SUNDRY NOTICES AND REPORTS ON WELLS

8. Well Name and No.
HGU #111

**Plugging and Abandonment Procedure
Horseshoe Gallup Unit No. 111
Attachment "A"**

CONDITIONS OF APPROVAL

WELL NAME III HCU
 SEC, TWN, RNG. 19-31N-16W

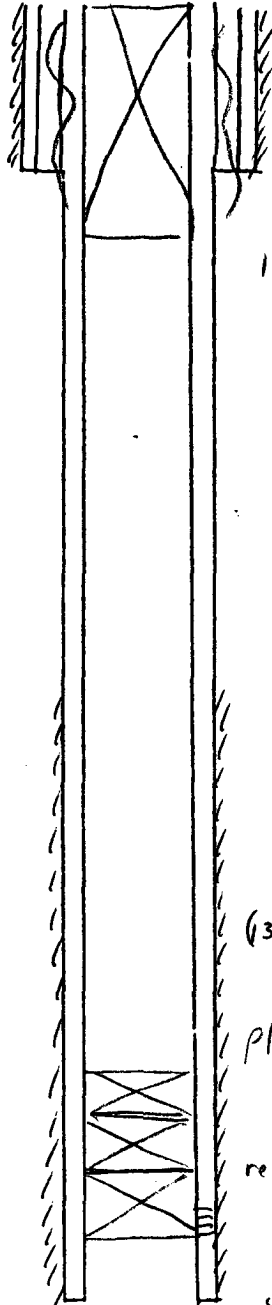
a) Bring the top of the Gallup plug to 1114'.

b) Place the Surface plug from 152' to surface inside and outside the 5 ½" casing.

152 - Surface w 50 SKS

$$\begin{aligned} 152 / 7.299 (1.18) &= 188 \text{ SKS} \\ 50 / 5.7719 (1.18) &= 7 \text{ SKS} \\ 102 / 5.192 (1.18) &= 17 \text{ SKS} \\ &= 42 \text{ SKS} \end{aligned}$$

TOC ≈ 752' 75% off.

$$(1325 - 1114) + 50 / 7.299 (1.18) = 30 \text{ SKS or greater}$$

Plug 1325 - 1114
